Access Compliance Report

Public Rights-of-Way

(Curb Ramps)

Intersection ID: 44919	Main Street: PALUSTRIS_CT	Cross Street: MINTVALE_DR	Location: SE
ADA ID: 51FB2C51E117	Ramp Type: PerpDiag	Initial Pass/Fail: Fail	Overall Compliance: No
Severity Score: 33.75			
Codes/Mitigation Info/Possible Solution		Field Measurements/Component Compliance

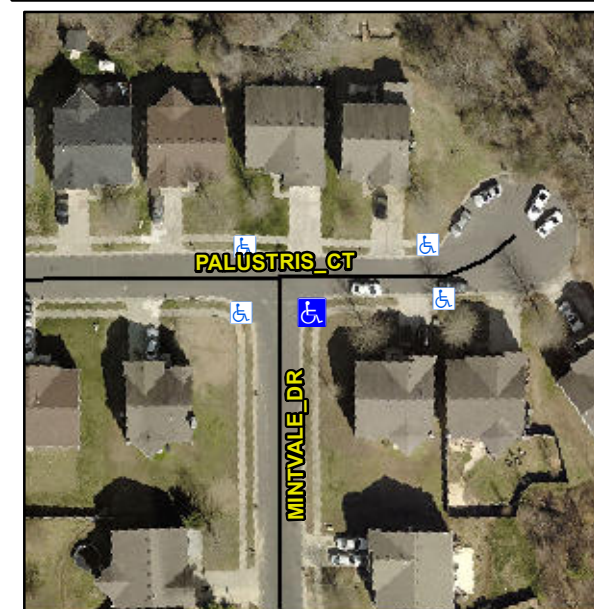
Not Found, R304.5.1, R304.2.2

Compliance	Description	Data	Compliance	Description	Data
N/A	Ramp Length (in)	47.5	No	Ramp Slope (%)	13.0
No	Ramp Width (in)	38.5	Yes	Ramp XSlope (%)	1.0
N/A	Flare Type LT	N/A	N/A	Flare Type RT	N/A
N/A	Flare Slope LT (%)	N/A	N/A	Flare Slope RT (%)	N/A
N/A	Flare Traversable LT?	N/A	N/A	Flare Traversable RT?	N/A
N/A	Landing Length (in)	N/A	N/A	DWS Provided?	N/A
N/A	Landing Width (in)	N/A	N/A	DWS Contrast?	N/A
N/A	Landing Slope (%)	N/A	N/A	DWS Length (in)	N/A
N/A	Landing X Slope (%)	N/A	N/A	DWS Full Width?	N/A
N/A	Landing Curb? (Y/N)	N/A	N/A	DWS Offset (in)	N/A
N/A	Shared Landing?	N/A			
N/A	Gutter Ponding?	N/A	N/A	Gutter Slope (%)	N/A
N/A	Gutter Lip Ht (in)	N/A	N/A	Gutter X Slope (%)	N/A
N/A	Painted X Walk1?	No	N/A	Painted X Walk2?	No
	X Walk 1 Direction	To N		X Walk 2 Direction	To W
N/A	X Walk 1 Width (in)	N/A	N/A	X Walk 2 Width (in)	N/A
	X Walk 1 Slope (%)	3.0		X Walk 2 Slope (%)	4.5
	X Walk 1 X Slope (%)	4.4		X Walk 2 X Slope (%)	2.6

N/A	Ramp inside XWalk1?	N/A	N/A	Ramp inside XWalk2?	N/A
	Road Slope (%)	0.3	N/A	Clear Space?	N/A
	Road X Slope (%)	5.2	N/A	Clear Space to XWalk (in)	N/A
N/A	Any Obstructions?	N/A	N/A	Storm Grate/Utility Hazard?	N/A
	Obstruction Type			Storm Grate/Utility Type	
		N/A			N/A
		Yes		Surface Condition? (G/P)	Good

Remove & Replace Curb Ramp With Two New Directional Ramps or Equivalent.
